Purchase College Solicitation # SU-031819  
Campus Roadways Rehabilitation Project

**SU-031819 RE-BID Additional Addendum**

June 20, 2019

Questions & Answers

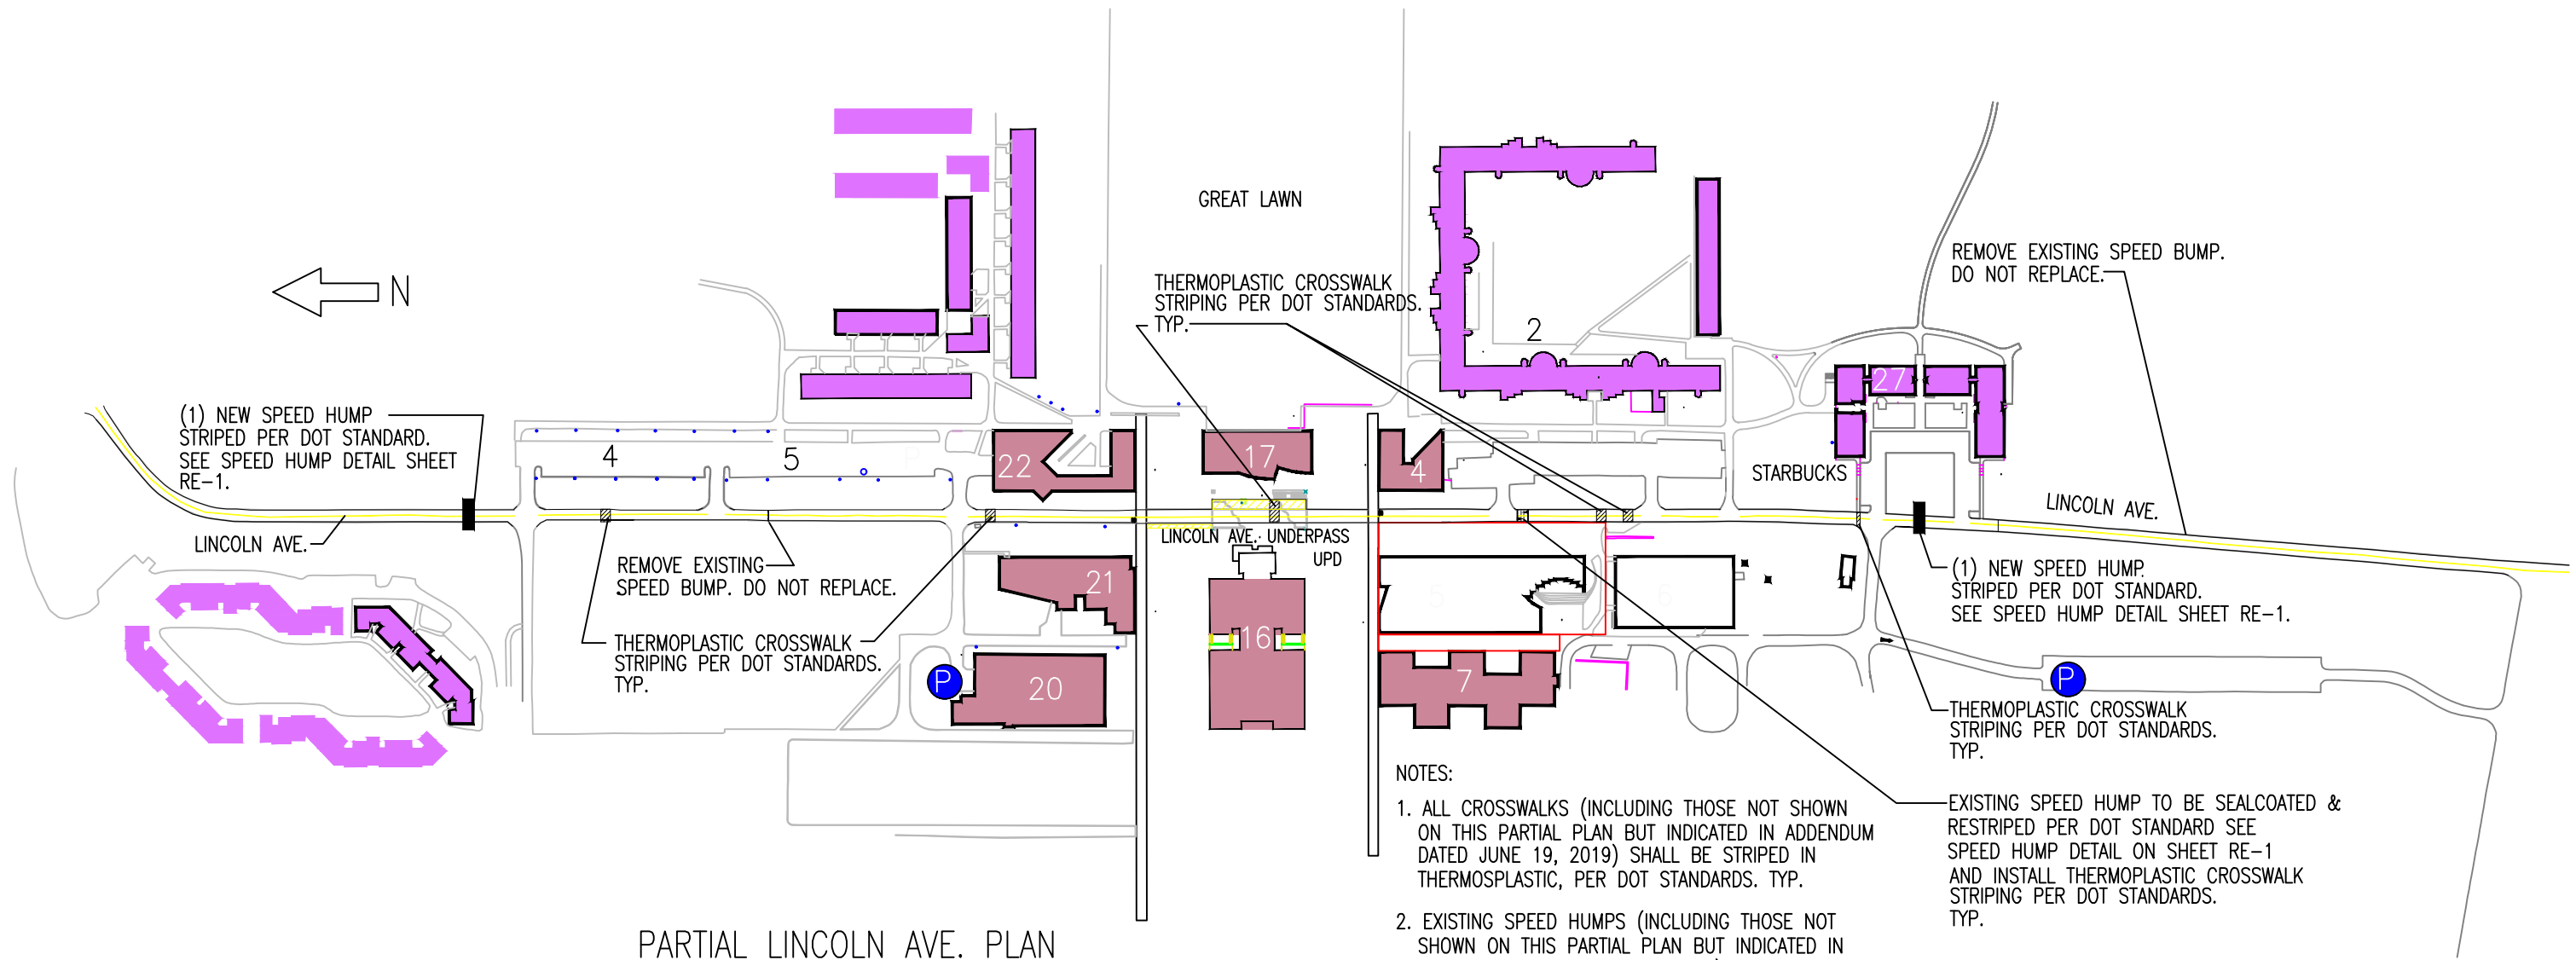
- 2) Note I – Removal section of asphalt walkway, grade and seed. We would like to clarify if it is going to the stone wall or is it going further than that. Picture is attached. And would you like the stone wall to be connected?

**ANSWER: REMOVE A PORTION OF THE EXISTING ASPHALT WALKWAY FROM THE EDGE OF LINCOLN AVE UP TO THE FIRST PARKING STALL. AREA SHALL BE PREPARED AND SEEDED. ALSO ADD CLOSING UP THE SMALL OPENING IN THE EXISTING STONE WALL WITH MATCHING STONE AND MORTAR.**
